TO: License Fee Management Branch  
FROM: Region I  
SUBJECT: ~~VOIDED~~ APPLICATION  
ABANDONED

Docket No. 030-33308  
Control No. 118639

This is in reference to your application dated August 10, 1993 for a byproduct material license. In order to continue our review, we need the following additional information:

Facilities—Annotated Drawing of the Radioisotope Facility

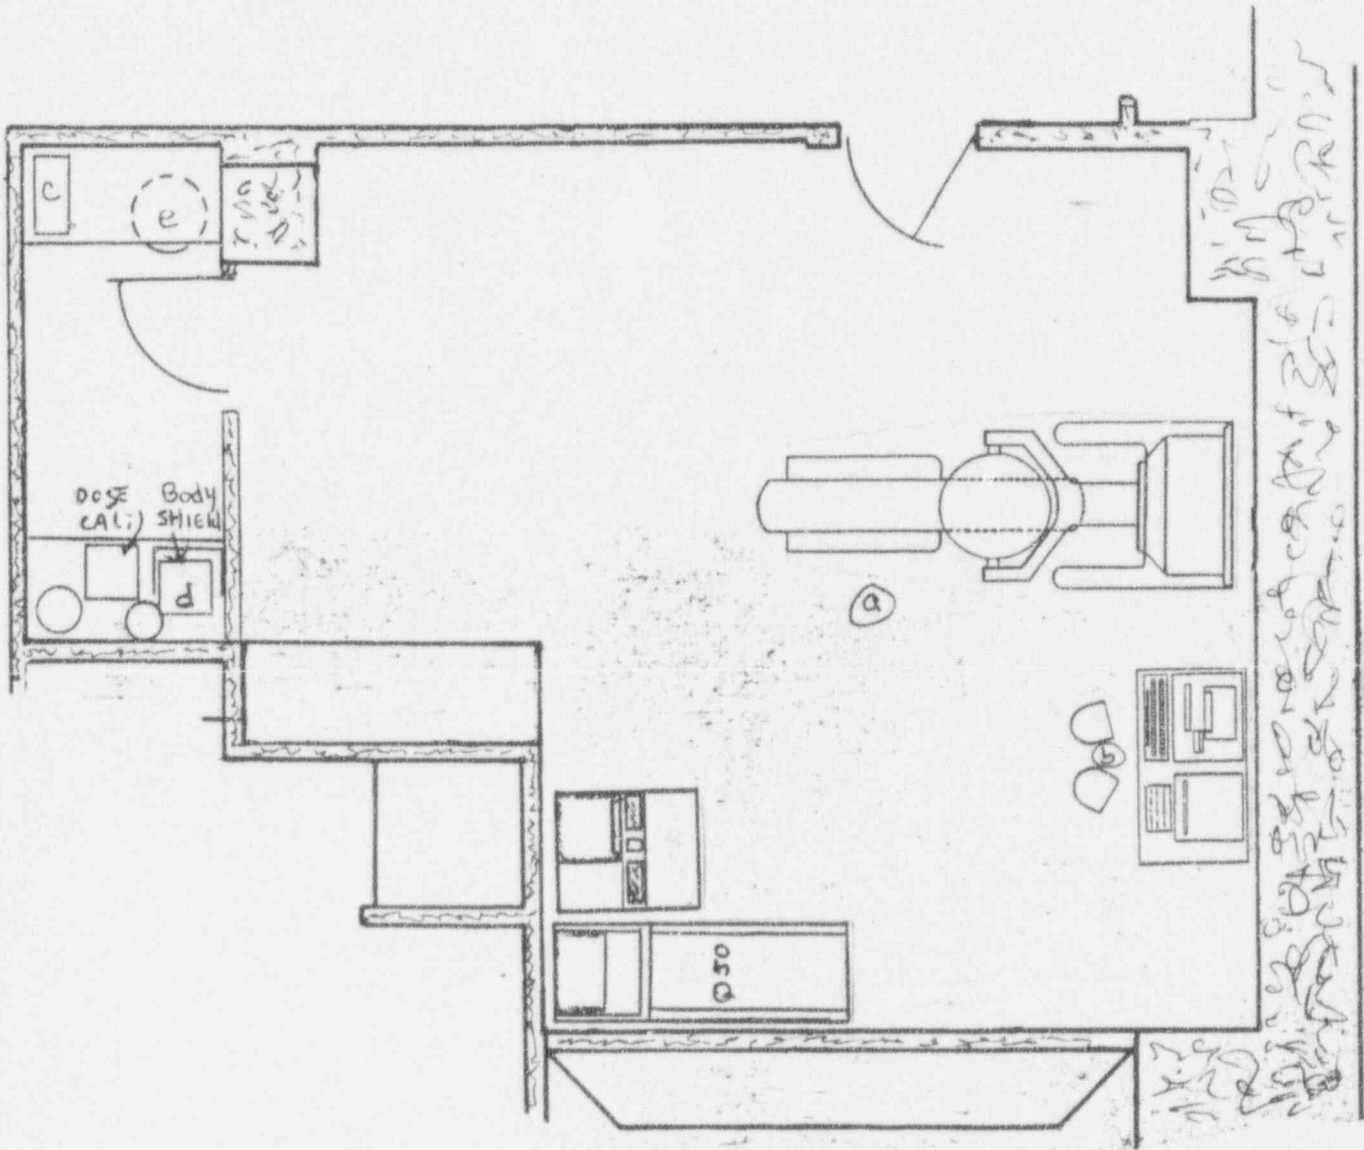
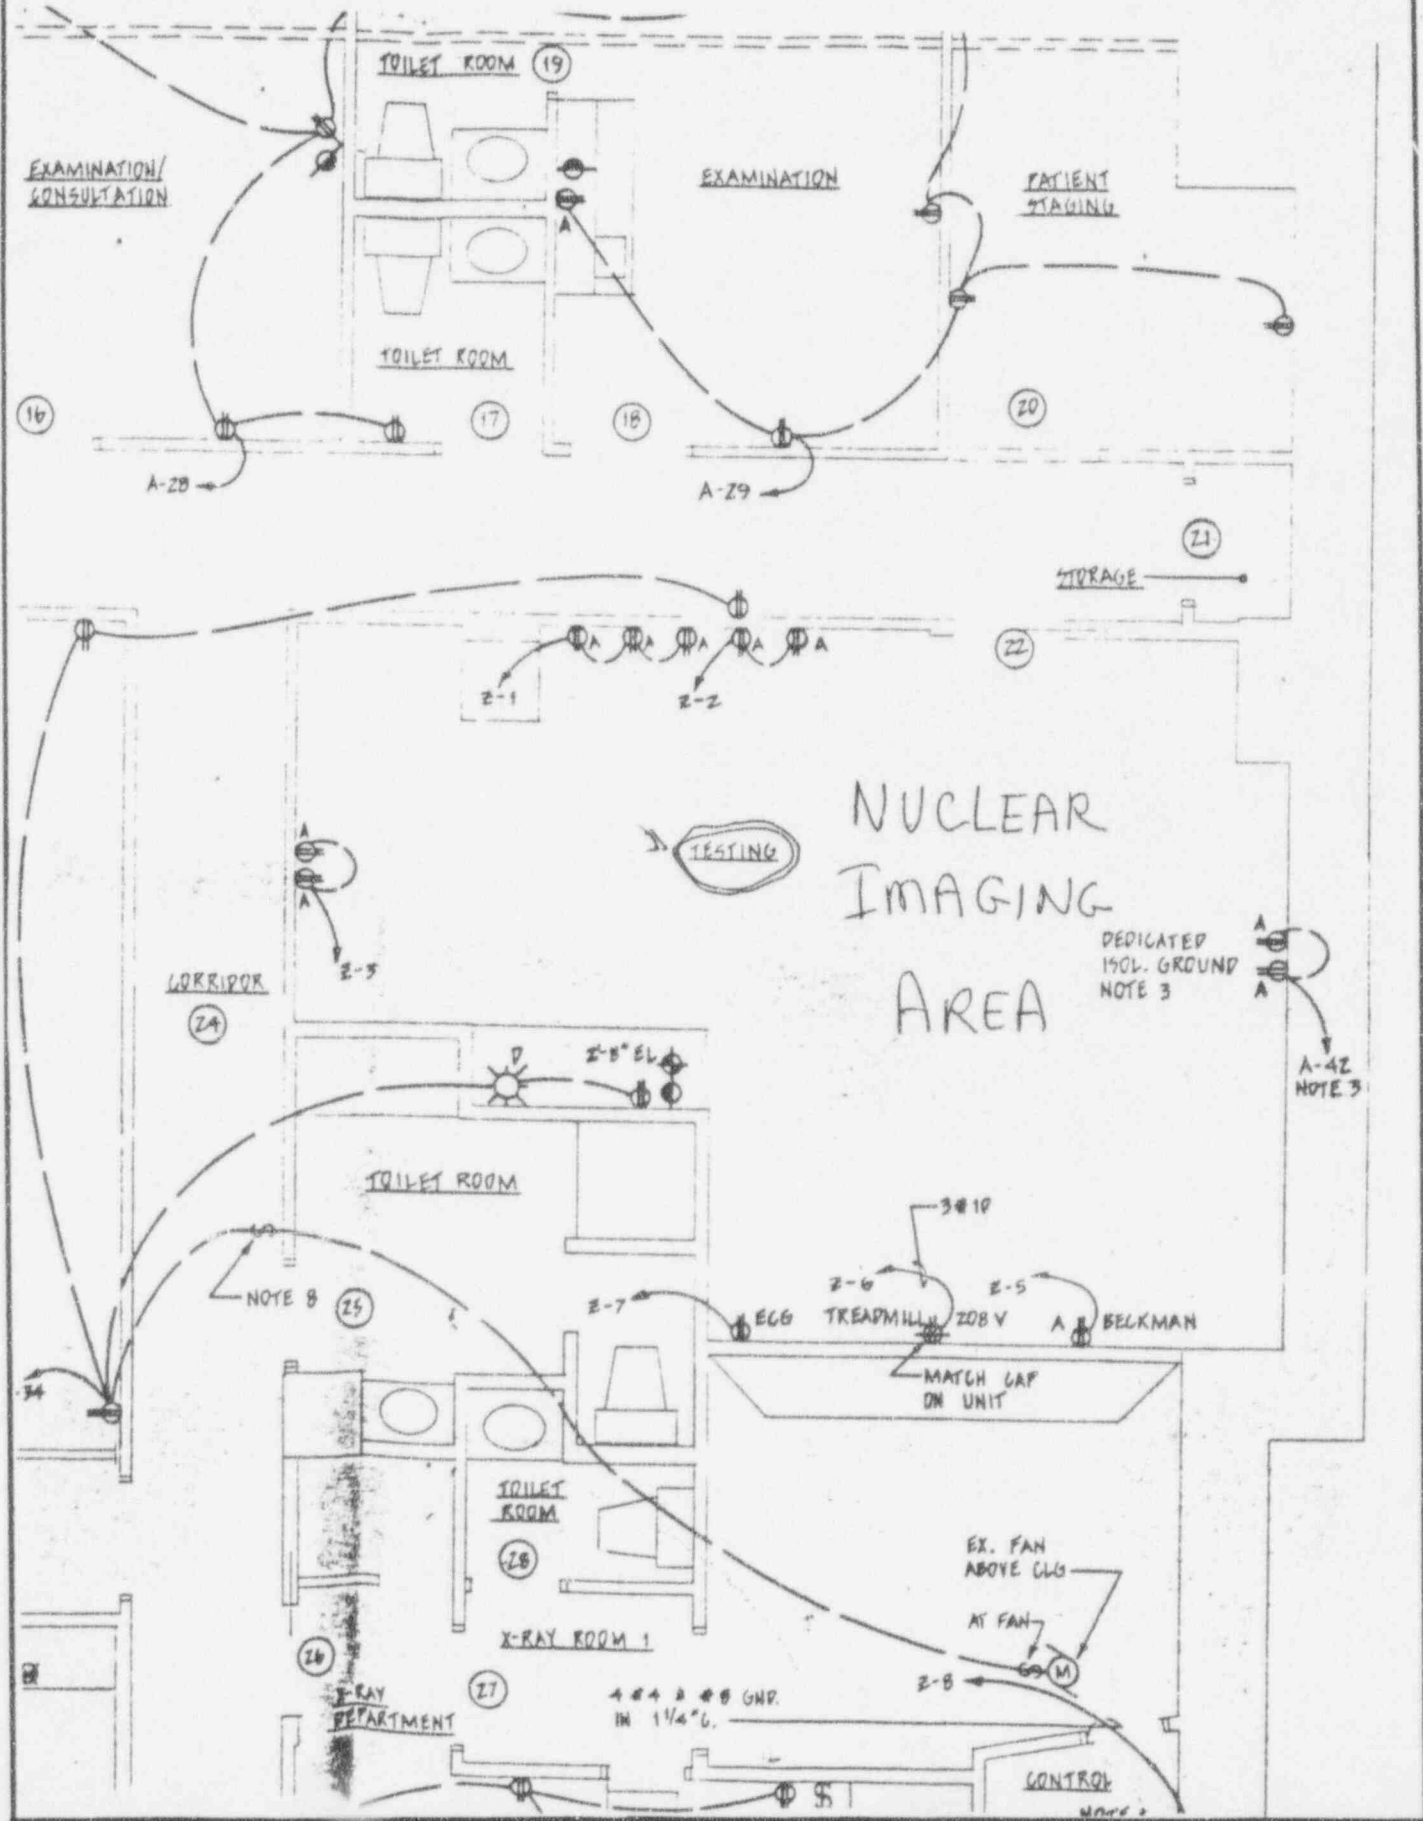
5. Attachment E2 indicates that NC Systems developed facility plans for Dr. Sharma. Please clarify; does the facility exist as depicted in the facility diagram or is the facility under construction? In addition, the plans that was submitted (developed by NC Systems) list the address as 1643 Pinoak Drive, Pittsburgh, PA 15237; the application indicates that the location of possession and use is 125 Seventh Street, 4th Floor, Pittsburgh, PA 15222. What is the correct location where byproduct material will be used or stored?
